Access Compliance Report Public Rights-of-Way (Curb Ramps)

Intersection ID: 46309	Main Street: BRIDLE_BROOK_WY	Cross Street: MERMANS_RD	Location: SW
ADA ID: 7200A8430C9E	Ramp Type: PerpDiag	Initial Pass/Fail: Fail	Overall Compliance: No Severity Score: 8.75

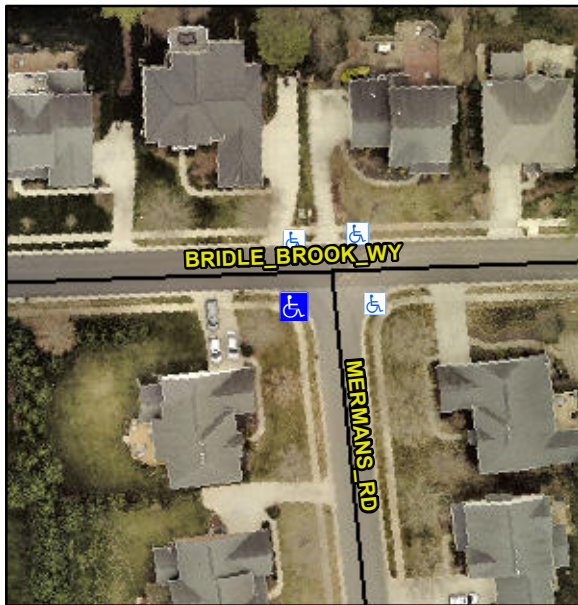
Not Found, R304.5.1

Compliance	Description	Data	Compliance	Description	Data
N/A	Ramp Length (in)	48.5	Yes	Ramp Slope (%)	5.0
No	Ramp Width (in)	44.5	Yes	Ramp XSlope (%)	0.4
N/A	Flare Type LT	N/A	N/A	Flare Type RT	N/A
N/A	Flare Slope LT (%)	N/A	N/A	Flare Slope RT (%)	N/A
N/A	Flare Traversable LT?	N/A	N/A	Flare Traversable RT?	N/A
N/A	Landing Length (in)	N/A	N/A	DWS Provided?	N/A
N/A	Landing Width (in)	N/A	N/A	DWS Contrast?	N/A
N/A	Landing Slope (%)	N/A	N/A	DWS Length (in)	N/A
N/A	Landing X Slope (%)	N/A	N/A	DWS Full Width?	N/A
N/A	Landing Curb? (Y/N)	N/A	N/A	DWS Offset (in)	N/A
N/A	Shared Landing?	N/A			
N/A	Gutter Ponding?	N/A	N/A	Gutter Slope (%)	N/A
N/A	Gutter Lip Ht (in)	N/A	N/A	Gutter X Slope (%)	N/A
N/A	Painted X Walk1?	No	N/A	Painted X Walk2?	No
	X Walk 1 Direction	To E		X Walk 2 Direction	To N
N/A	X Walk 1 Width (in)	N/A	N/A	X Walk 2 Width (in)	N/A
	X Walk 1 Slope (%)	1.9		X Walk 2 Slope (%)	0.4
	X Walk 1 X Slope (%)	0.4		X Walk 2 X Slope (%)	1.3

Remove & Replace Curb Ramp With Two New Directional Ramps or Equivalent.
